JANUARY 2020

PL6

NON MATERIAL
AMENDMENT
PLANNING
APPLICATION
& CONDITION 4
DISCHARGE

44 A GLOUCESTER
AVENUE LONDON
NW1 8JD

2.2 CHANGES TO CONSENT-ED DEMOLITION FIRST AND SECOND FLOORS

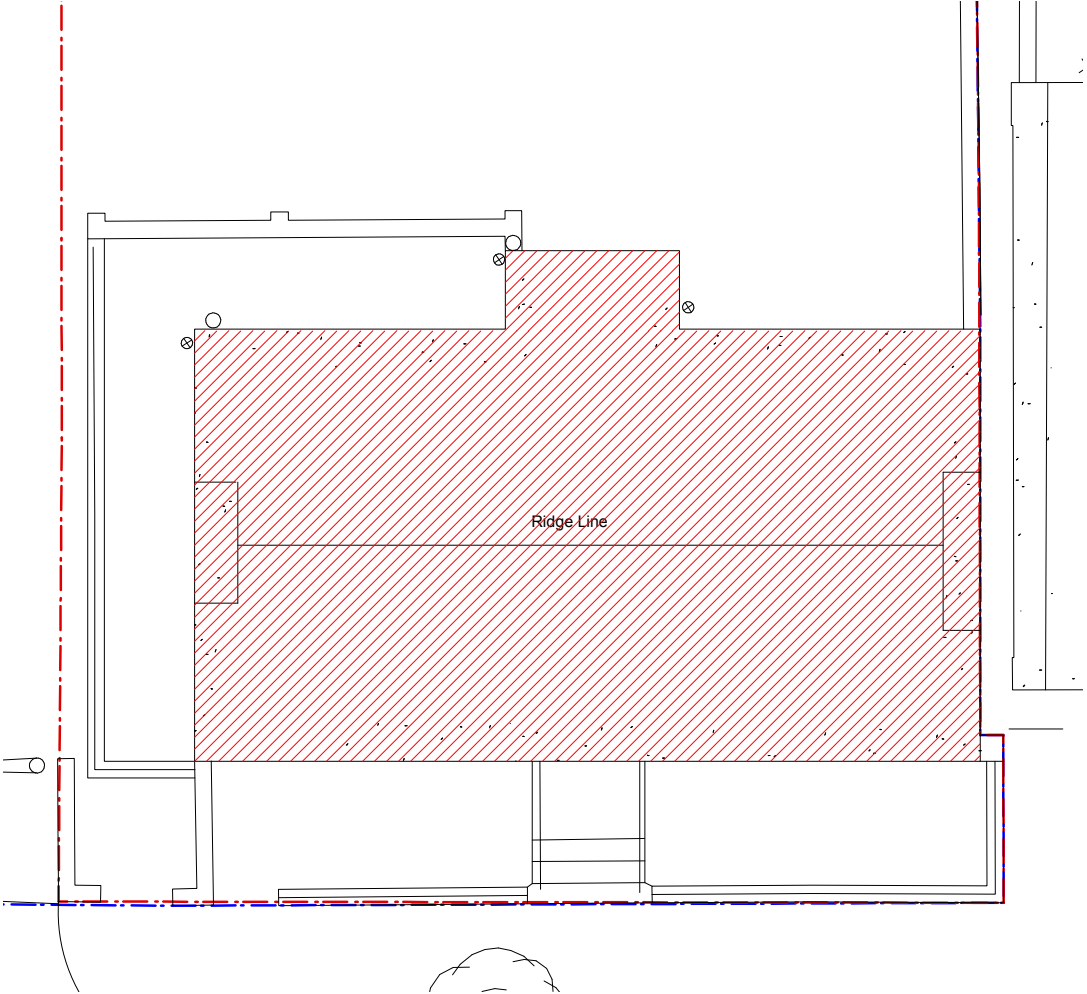
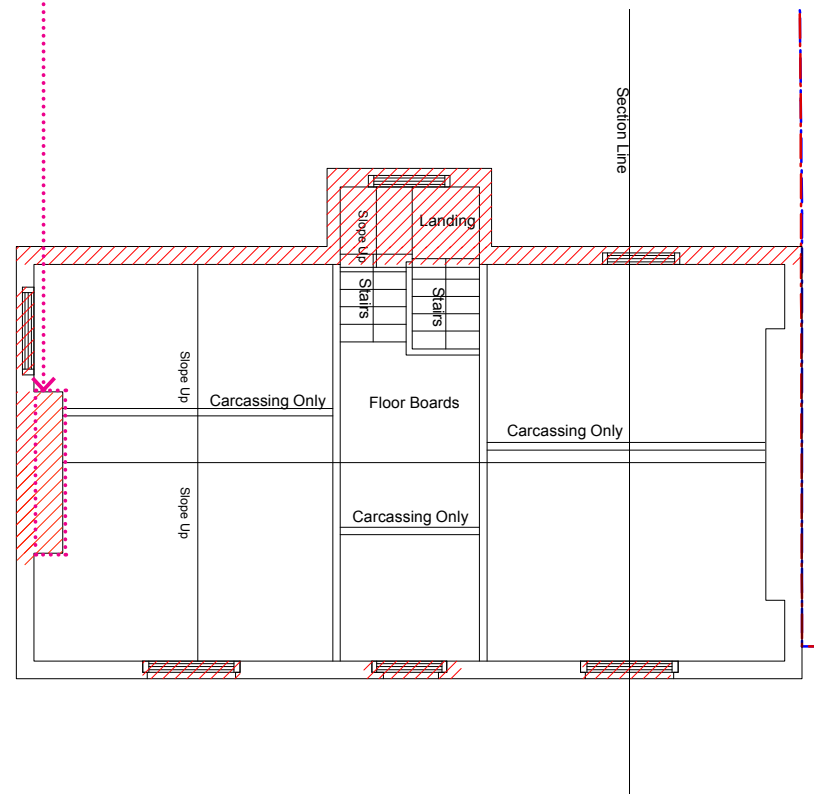
Additional opening made for the new window.
Internal chimney breast to be demolished due
to poor existing condition

2.4 CHANGES TO CONSENTED DEMOLITION FRONT ELEVATION

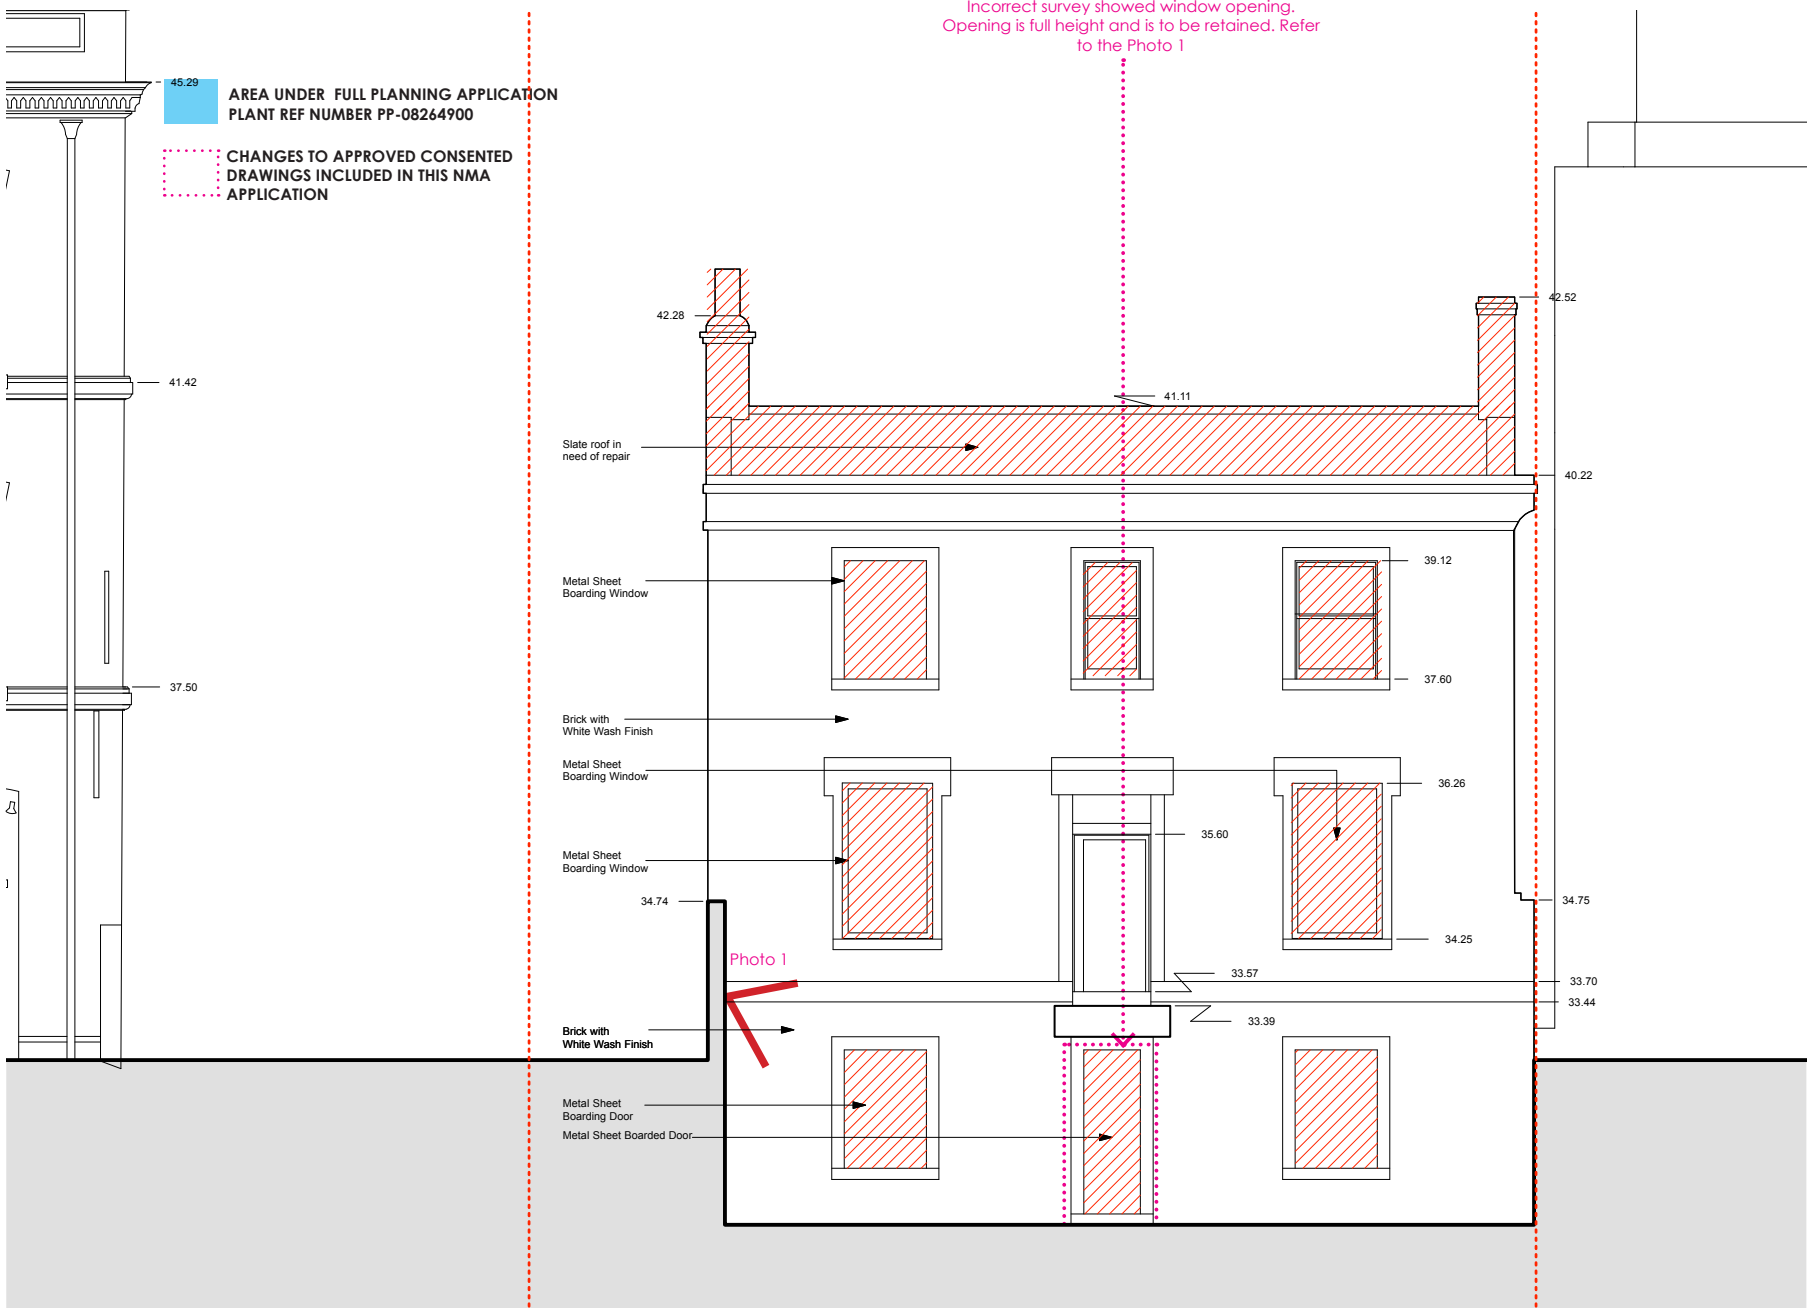
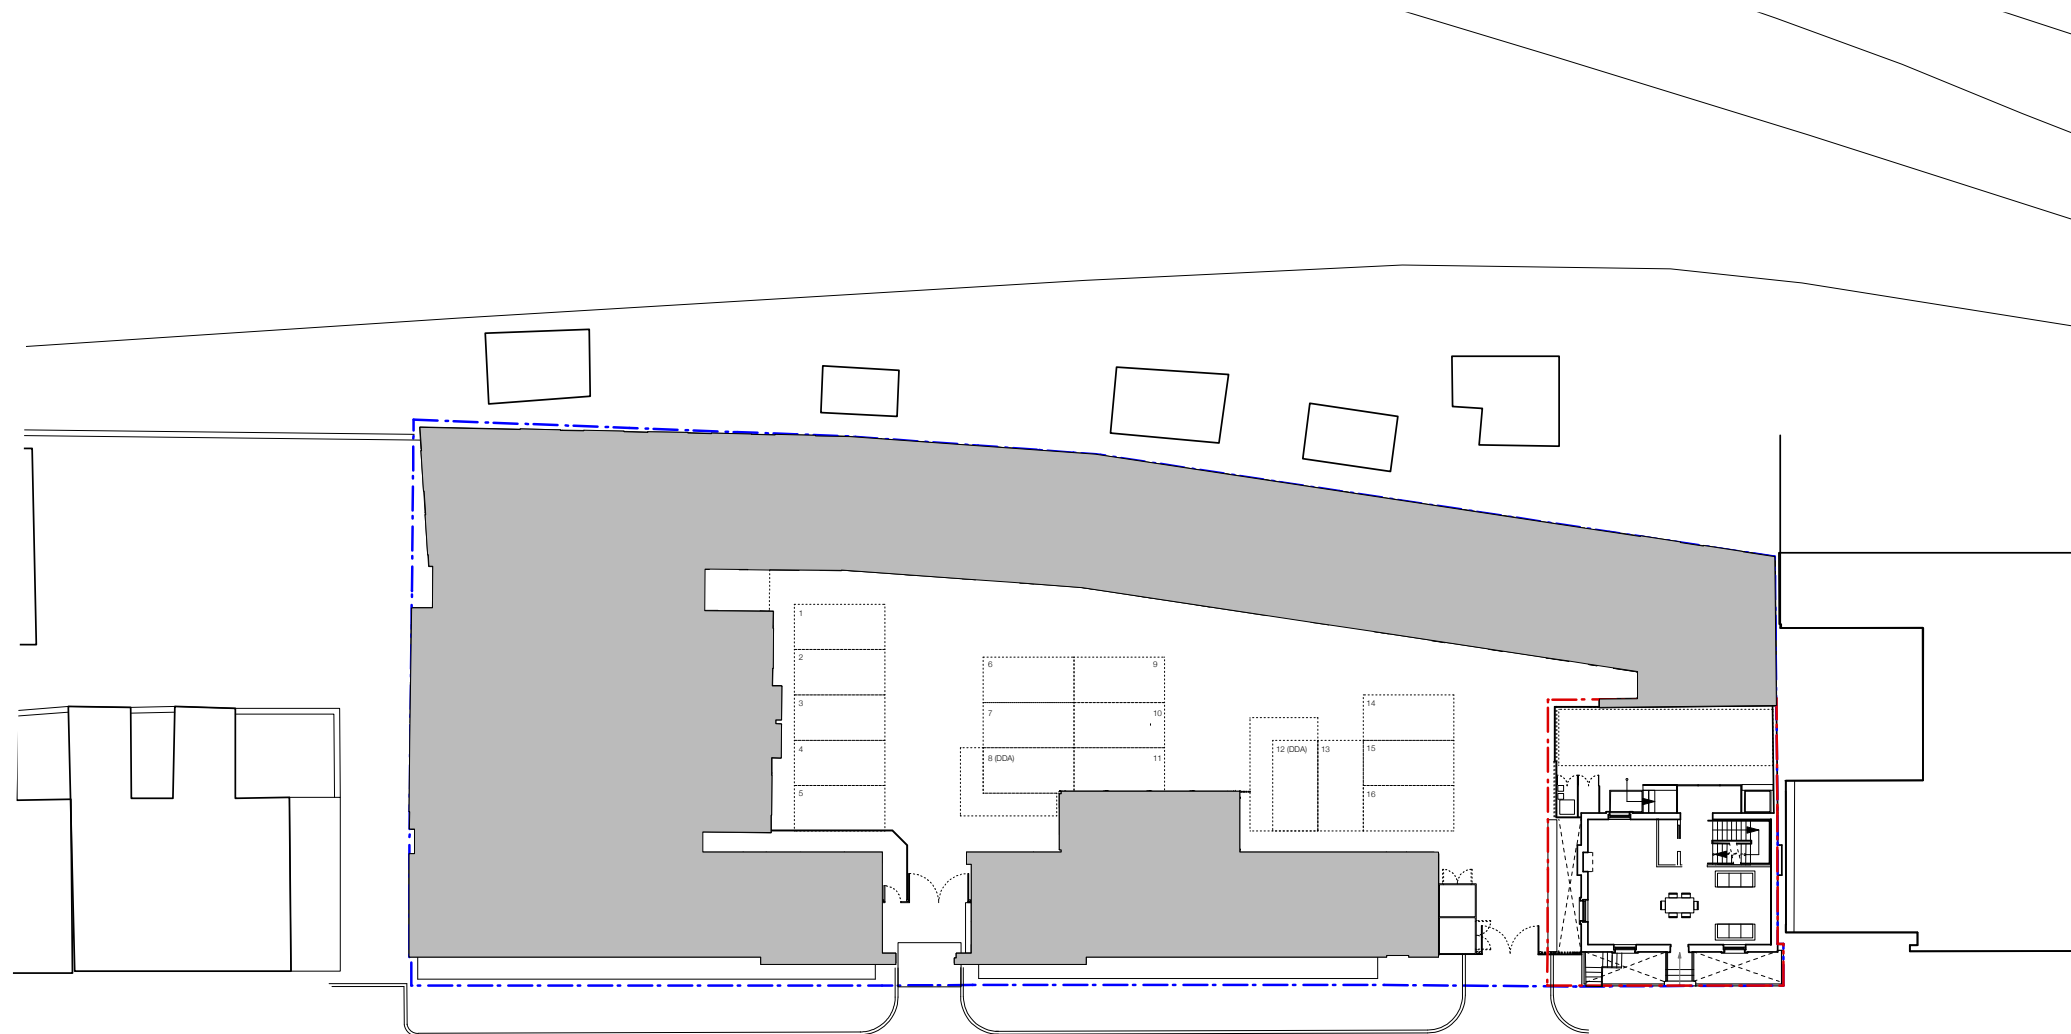
PHOTO 1. PHOTO OF THE EXISTING FULL HEIGHT OPENING

3.1 ADDITIONAL INFORMATION NEW ELEMENTS TO REAR COURTYARD

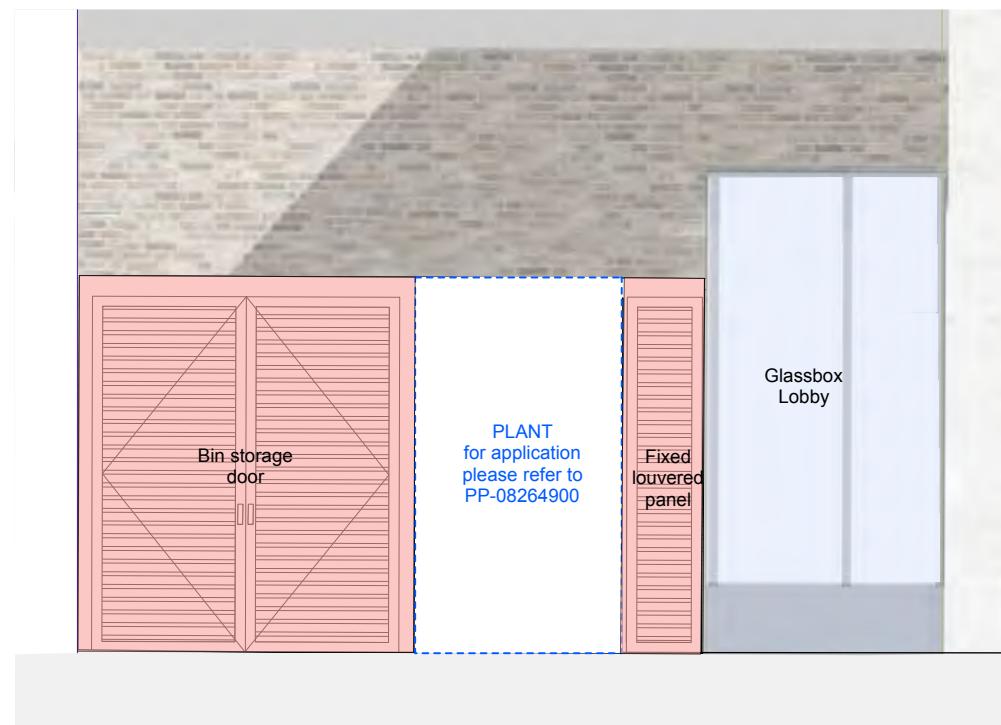
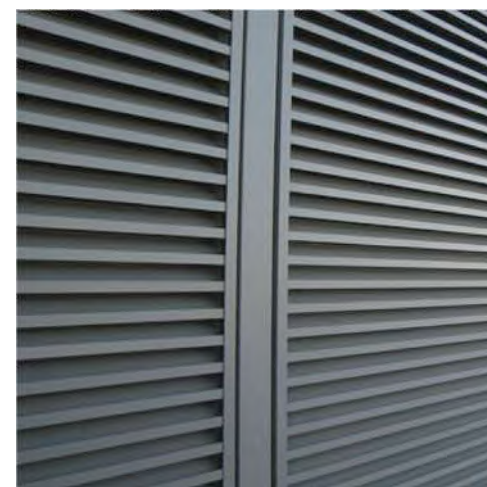
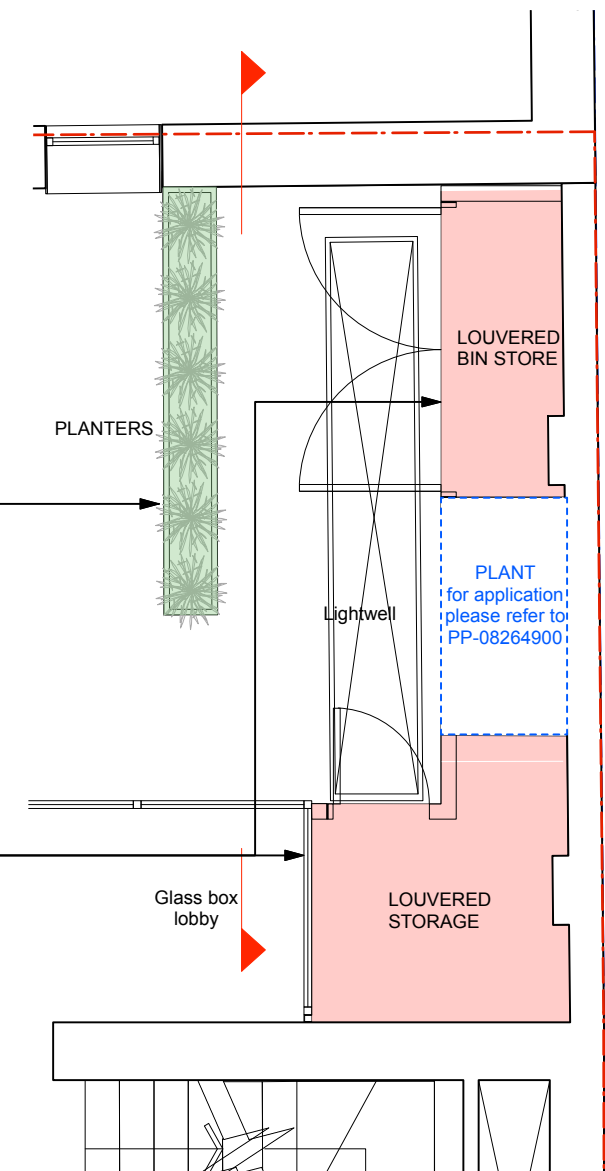
Planters

Aluminium Power Coated Louvers
RAL colour 7043
For Acoustic Spec refer to Full
Planning Application PP-08264900

3.2 ADDITIONAL INFORMATION- NEW MATERIALS

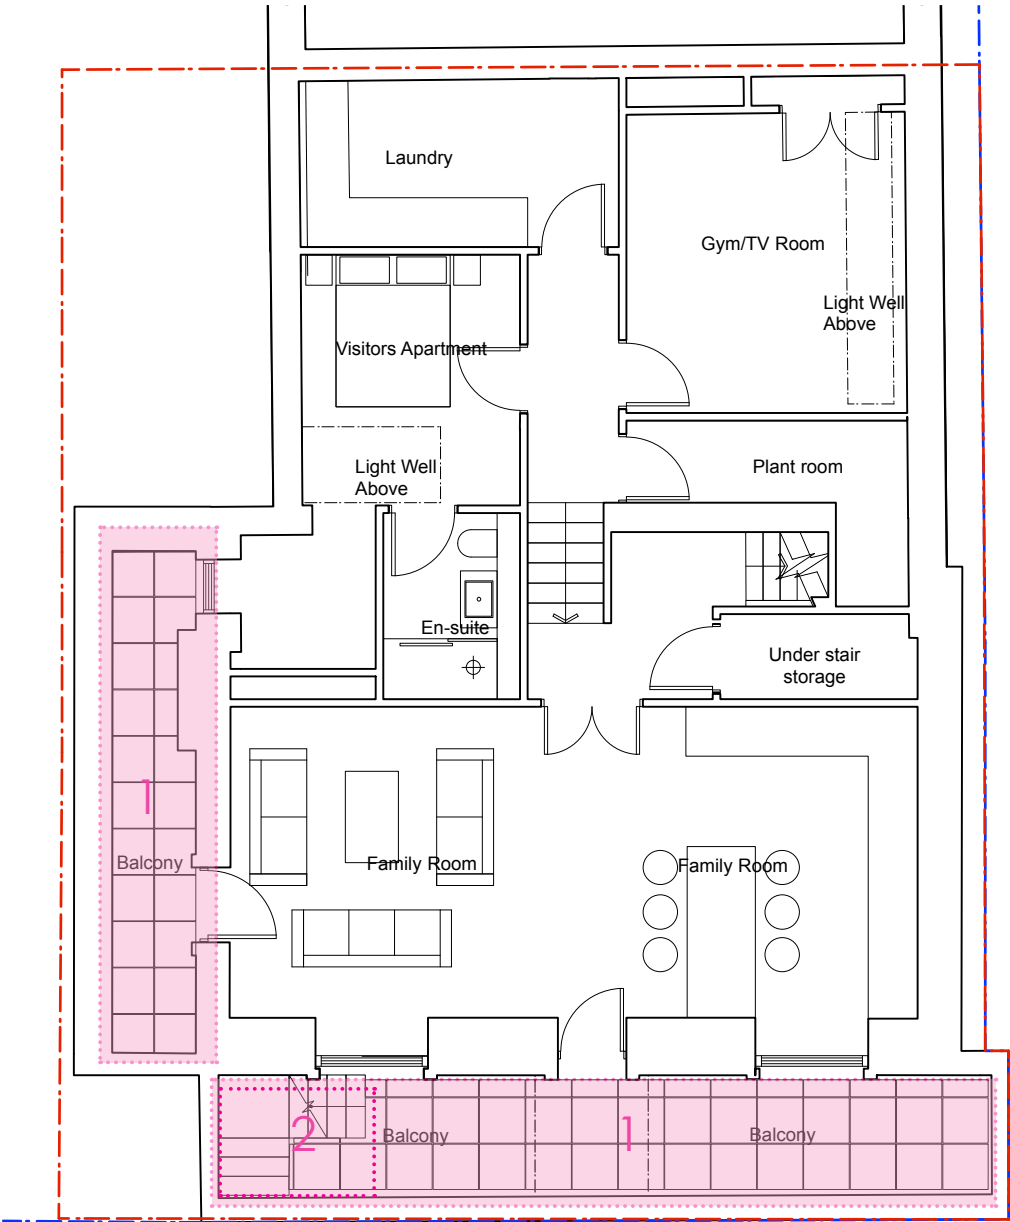
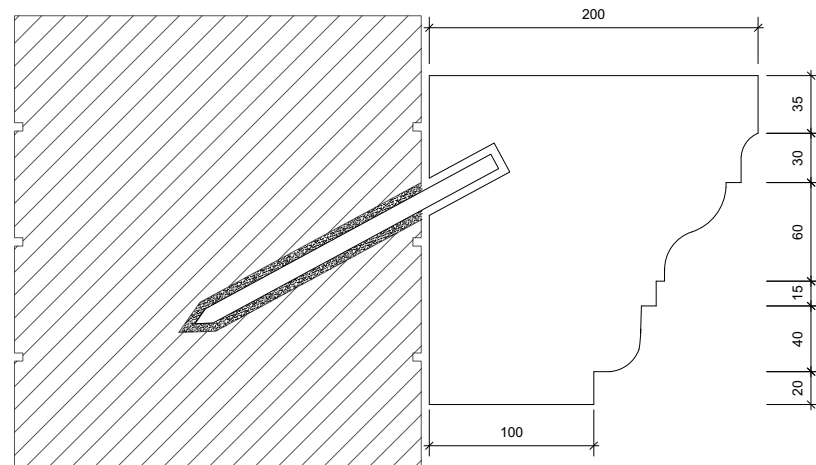
1. Balconies (lightwells) to the side and front elevation of the house have paving which is deteriorating and in poor state. Proposal includes those pavers to be Yorkstone to match the original intended design,

2. Existing external staircase is in poor condition and we are proposing complete replacement of the existing staircase. Proposal would include staircase to have matching metal handrail and Yorkstone threads as per intended original design.
